LINCOLN PARK PLANNING COMMISSION

Site Plan Review

Applicant	Clearwave Management, LLC
Project	Car Wash
Address	3727 Dix Hwy. Lincoln Park, MI 48146
Date	April 14, 2021
Request	Site Plan Review
Recommendation	Approval with Conditions

REV:
SHT# **C2.0**
JOB No: 21W0009

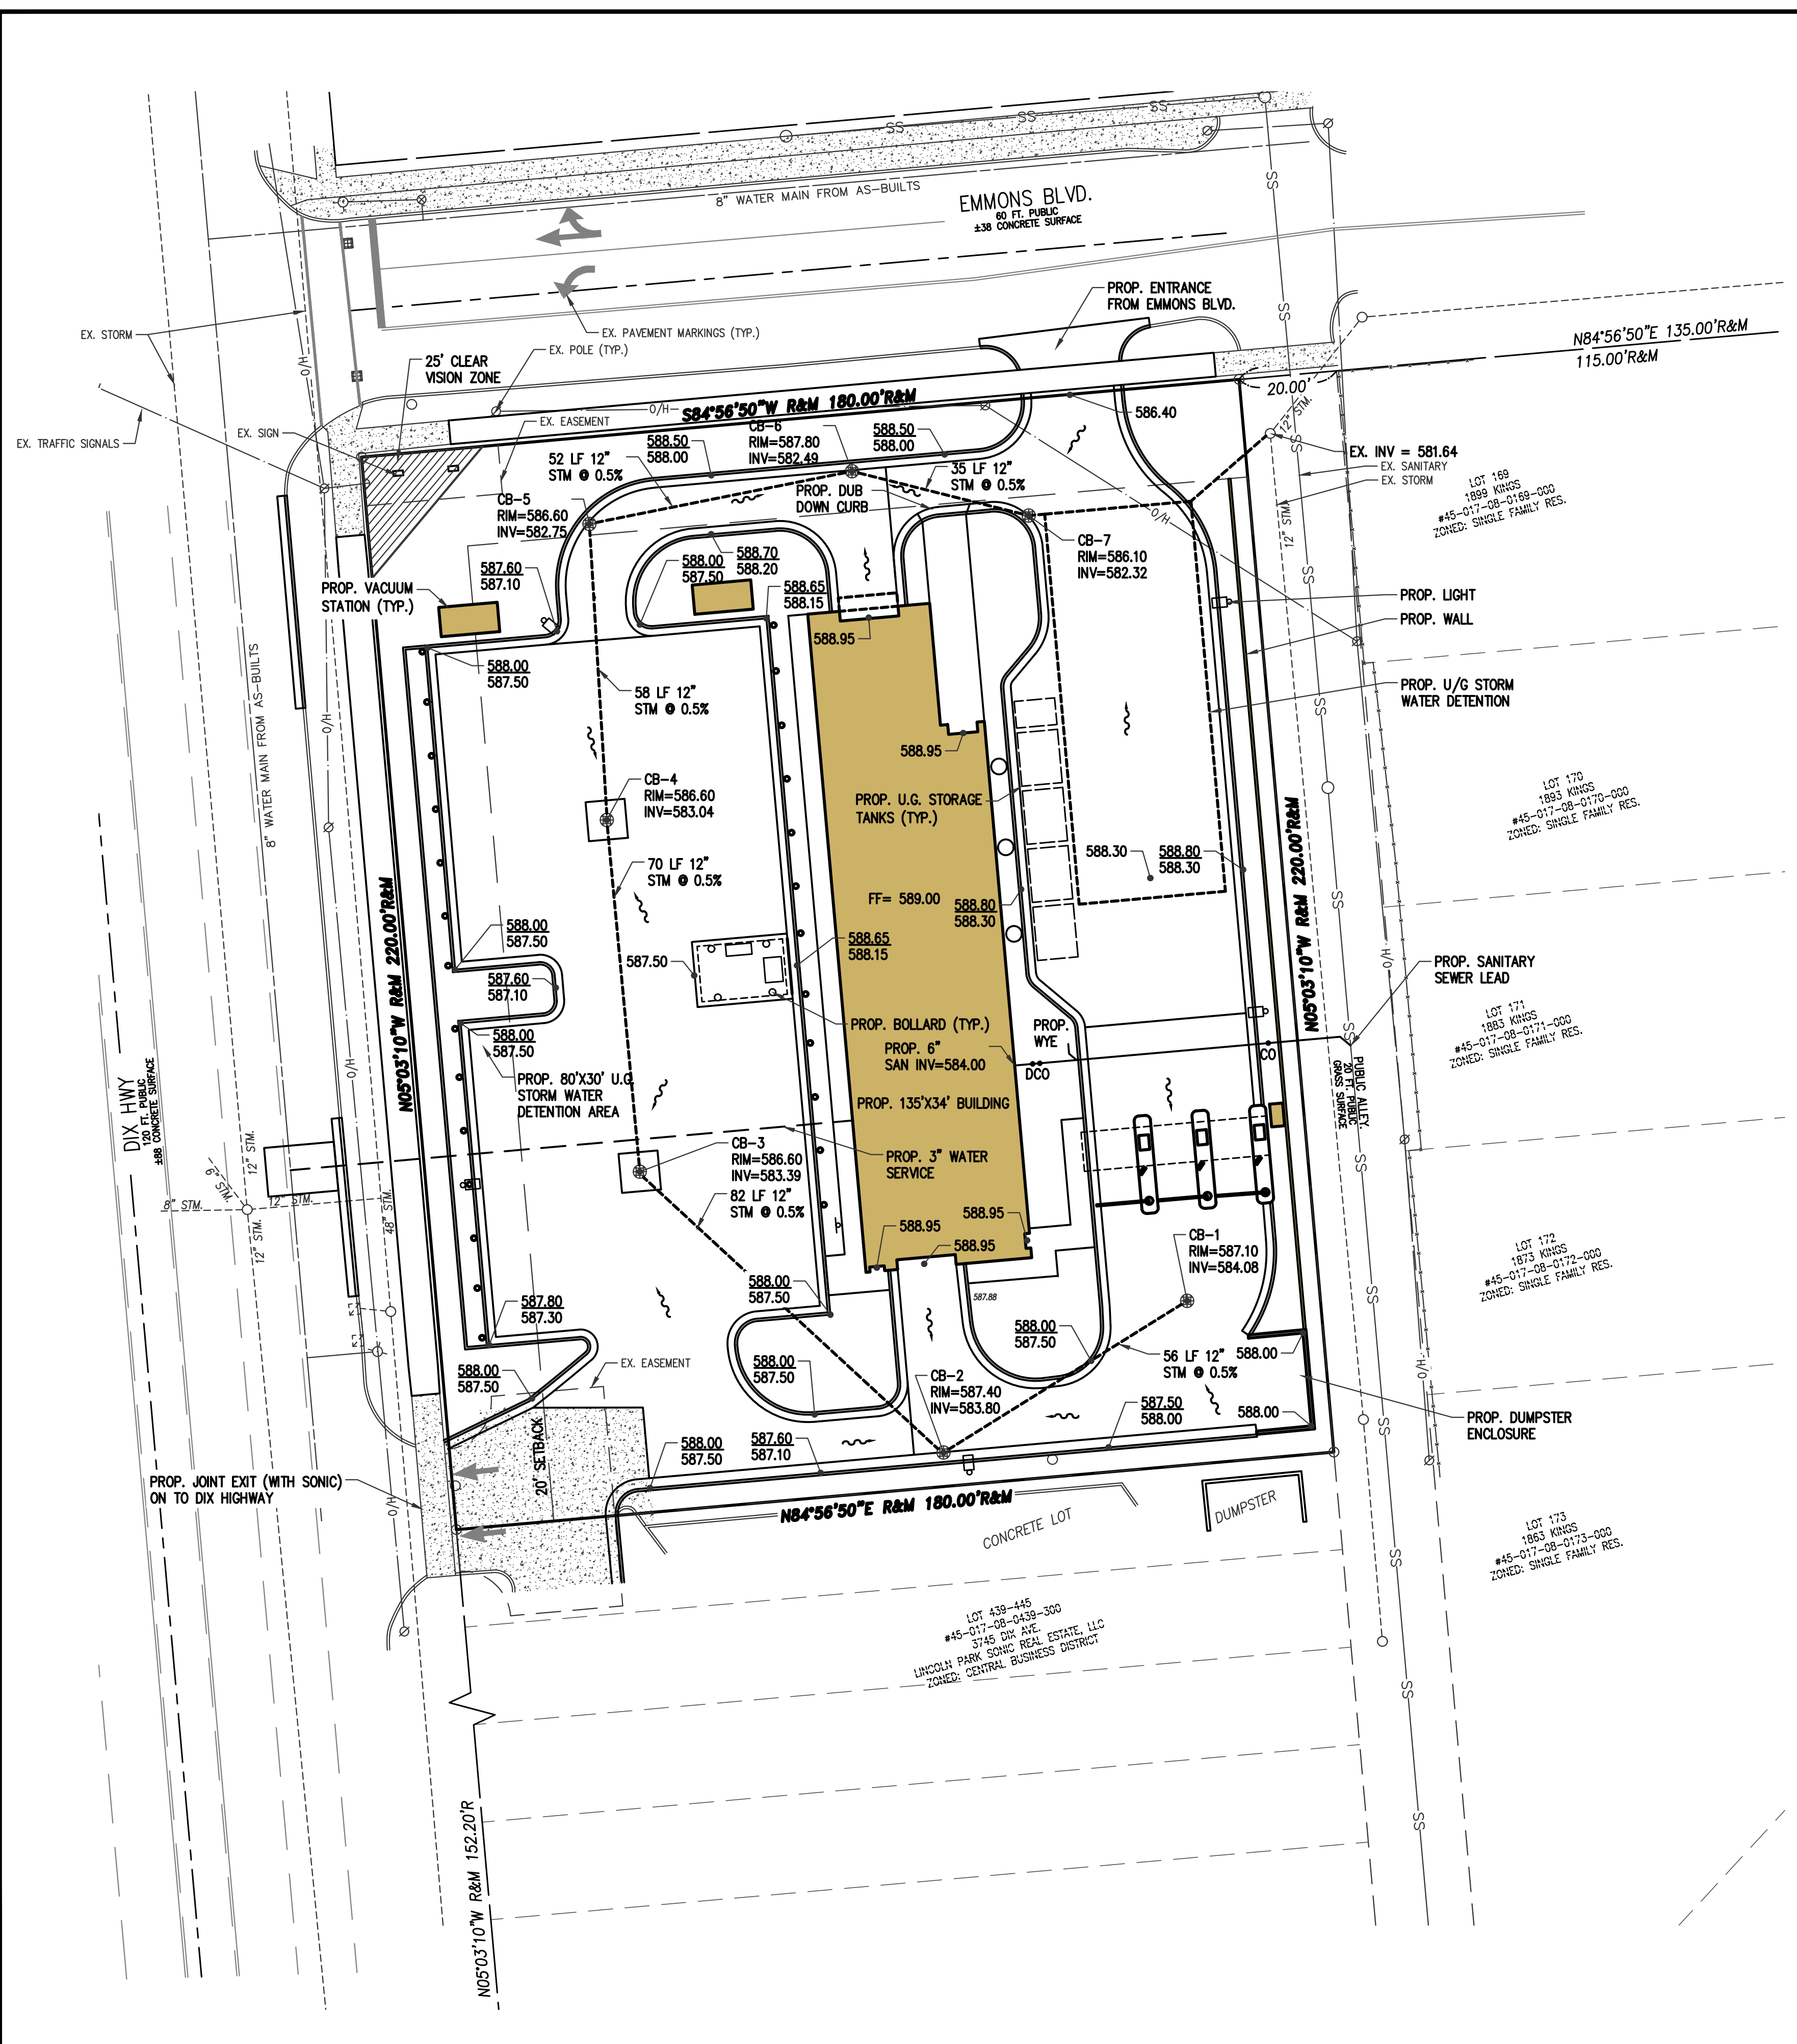
- Applicant shall provide drive radii on plan.
- Applicant shall provide the shared access agreement for the egress drive.
- Applicant shall provide documentation of the access easement for the egress drive.

- Applicant shall provide the required stacking space dimensions (10 ft. wide x 24 ft. long).

4345 44th Street SE, Suite A
 Kentwood, MI 49512
 O: (616) 272-7125
 F: (800) 974-1704
 www.rowepsc.com
 PREPARED FOR
DCC CONSTRUCTION
CLEAR WAVE CAR WASH
 LANDSCAPE PLANTING PLAN
 REV:
 SHT# C4.0
 JOB No: 21W0009

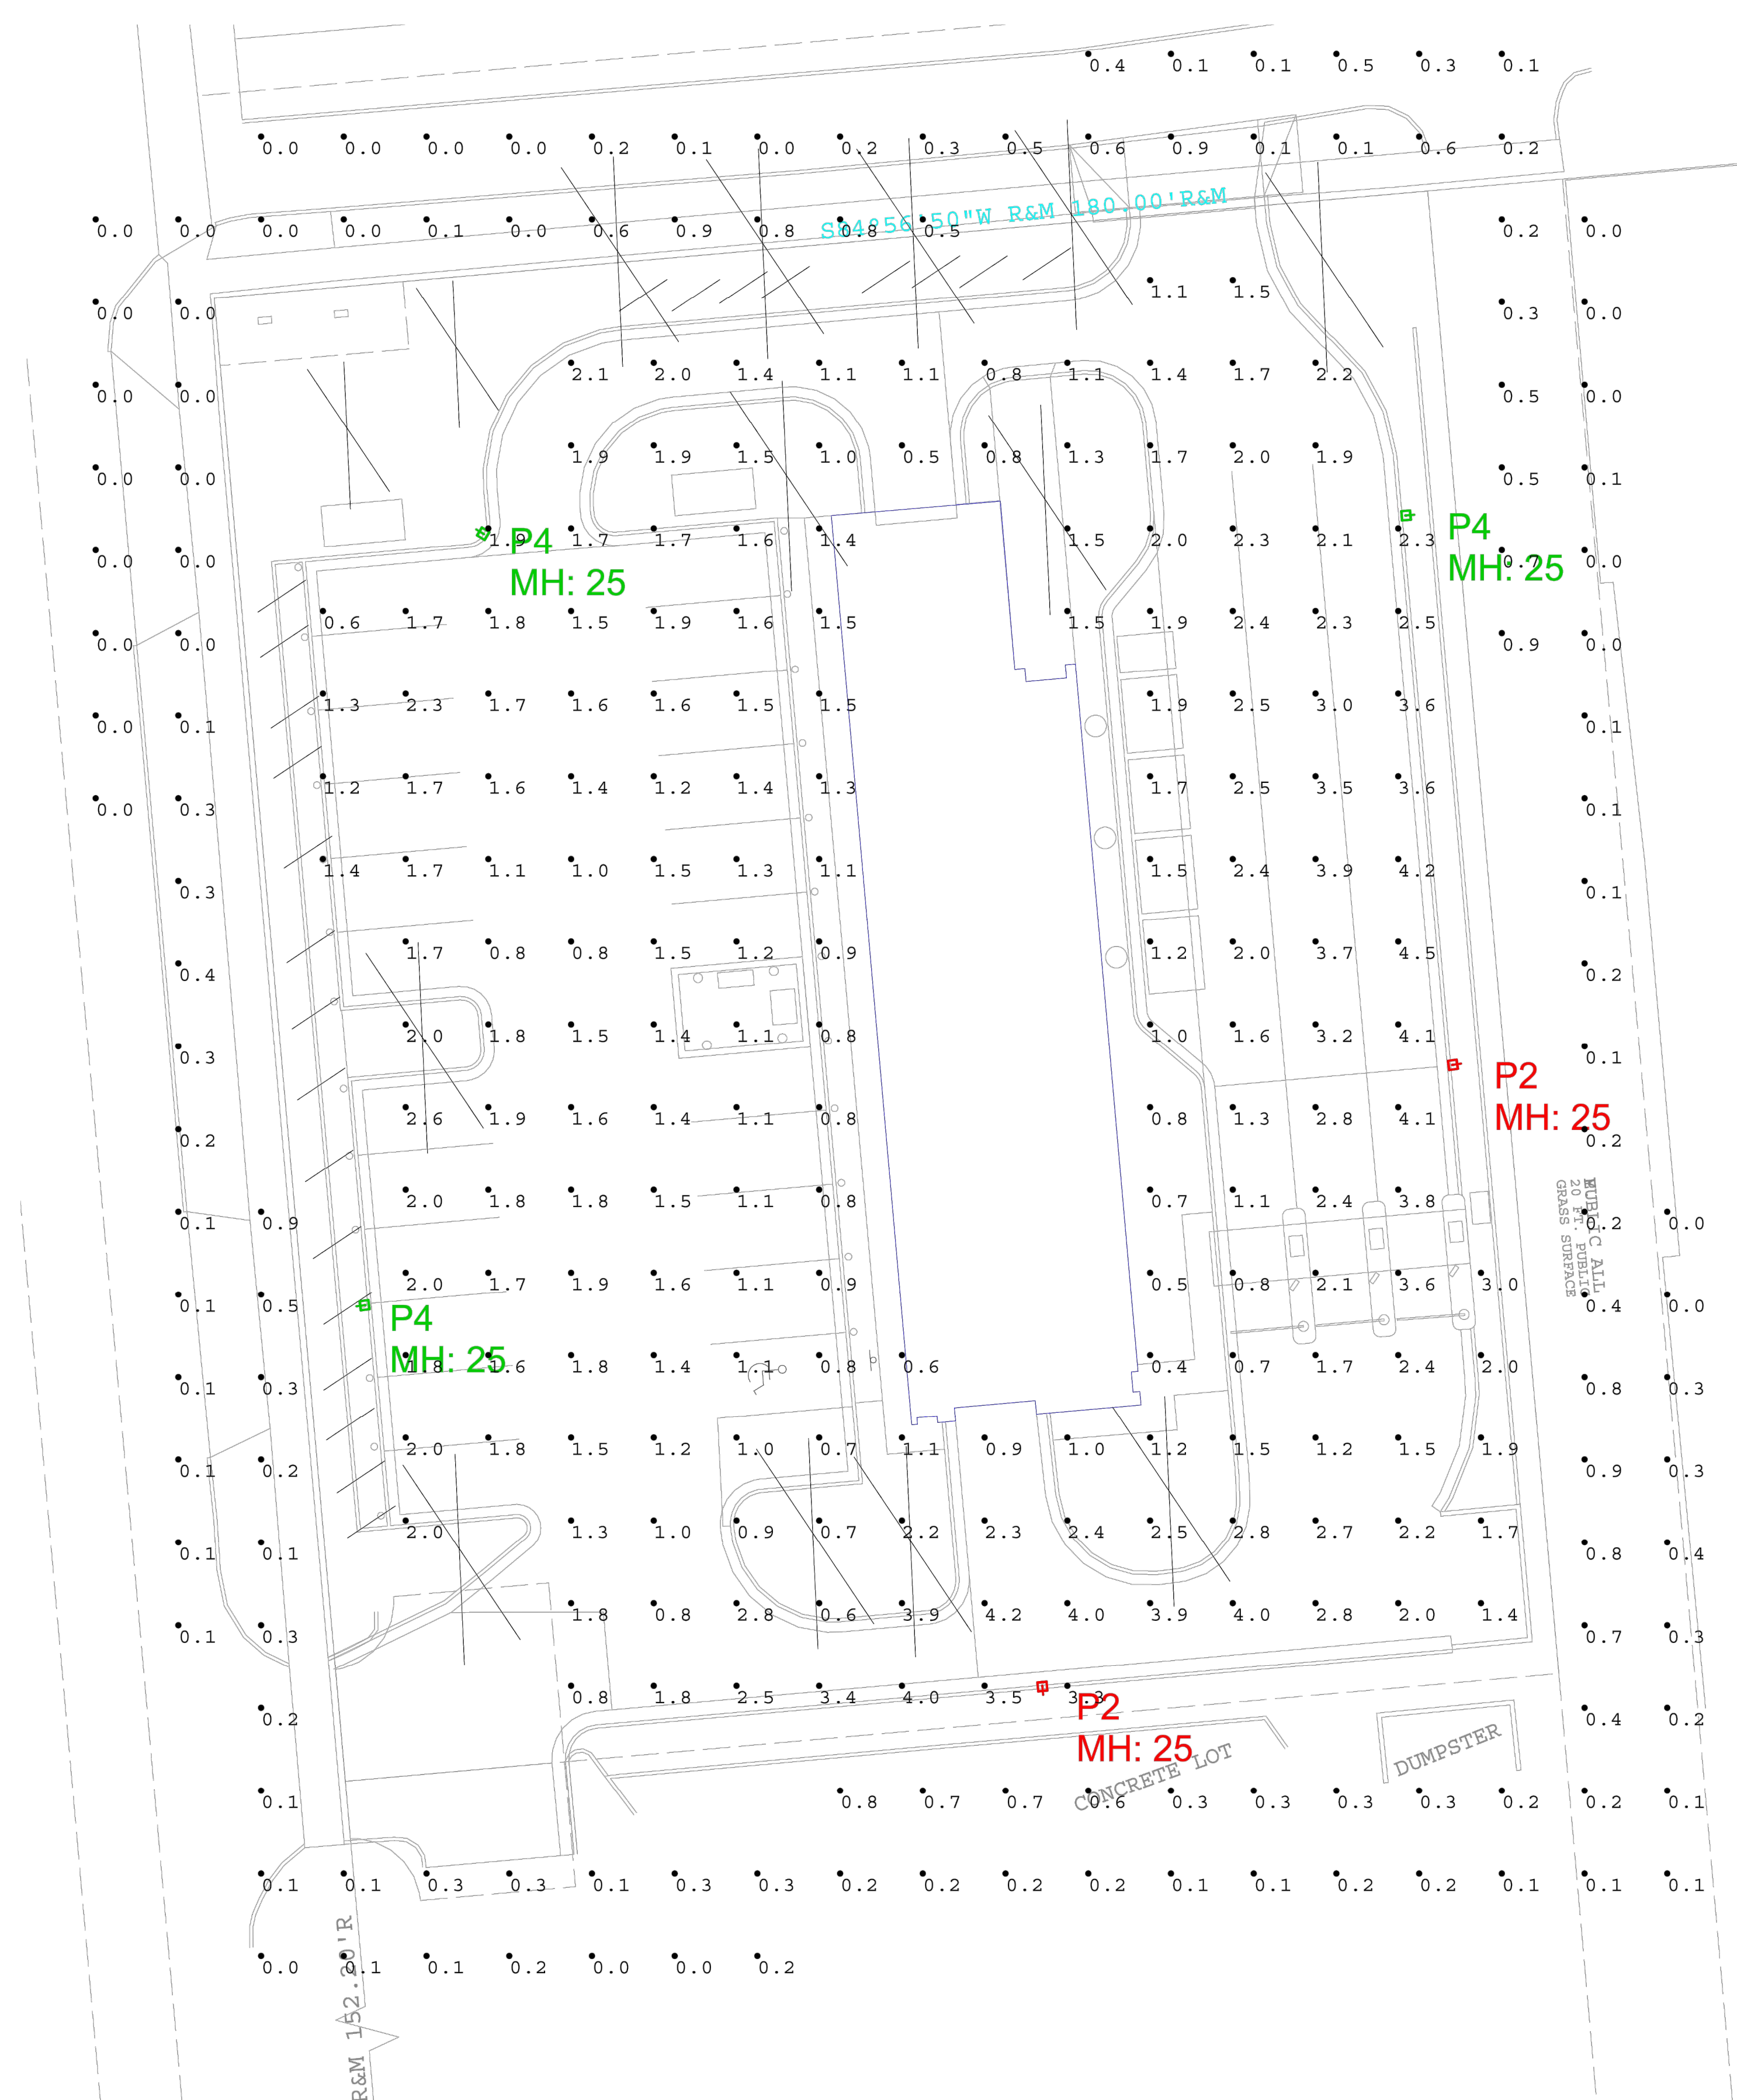
- Applicant shall provide the required number of street trees.
